TOWN OF ACTON  
DESIGN REVIEW BOARD  
**Memorandum**

July 7, 2021

Re: Acton Zoning Bylaw Lot Width and Lot Area Discussion

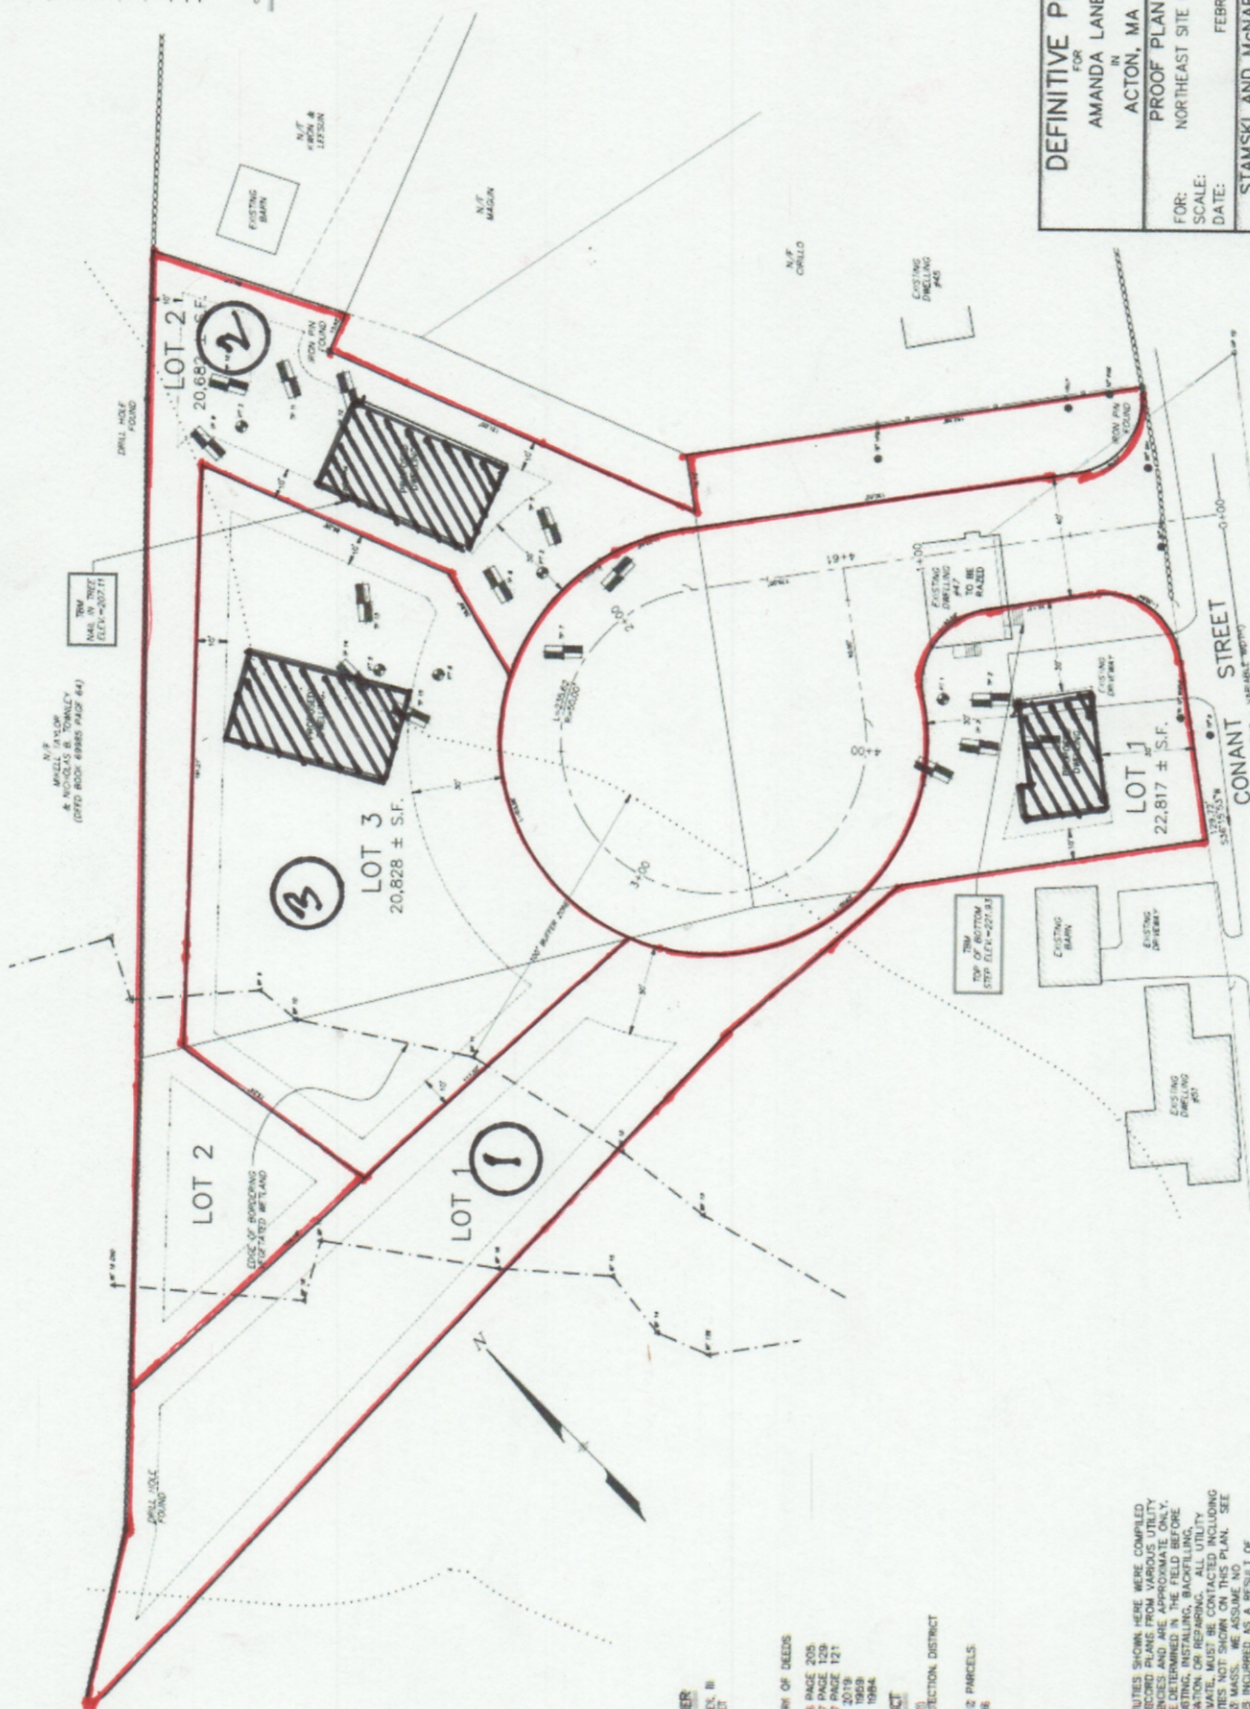
Using Exhibit 2 (Fletcher Court) as an example, a careful examination of the boundary lines of the 10 lots shown in this plan raises fundamental questions for developments of this kind, such as, but not limited to:

- With such grossly distorted lot shapes how can a future property owner even identify their lot boundaries?
- Using Lot #2 as an example, if a future owner wanted to install fencing along their lot boundary how would that even be possible or practical with such an impossibly narrow "sliver" of land that runs parallel to Lot #3?
- Using Lots #6 and #8 as examples, how would a future owner access the trapezoidal areas with heavy equipment and materials to say to install a pool, large garden or other property improvement to which they are entitled?

- Using Lot #3 as an example, what prevents this owner from easily and constantly trespassing onto the “sliver” of land created by Lot #2?
- Why create 20,000SF lots if portions of the property are virtually inaccessible or so distorted as to be un-useable for open space, recreation or other typical suburban uses?

- When looking at the dispositions of the house locations on Lots #4, #6 and #7, how is Acton’s residential historical character (i.e. the relationship of a dwelling to its lot and the relationship of dwellings to adjacent dwellings) preserved, as called for in the Acton 2020 Master Plan, when this uncomfortable and inappropriate relationship between these houses is due solely to the creation of their bizarrely-shaped lot boundaries?
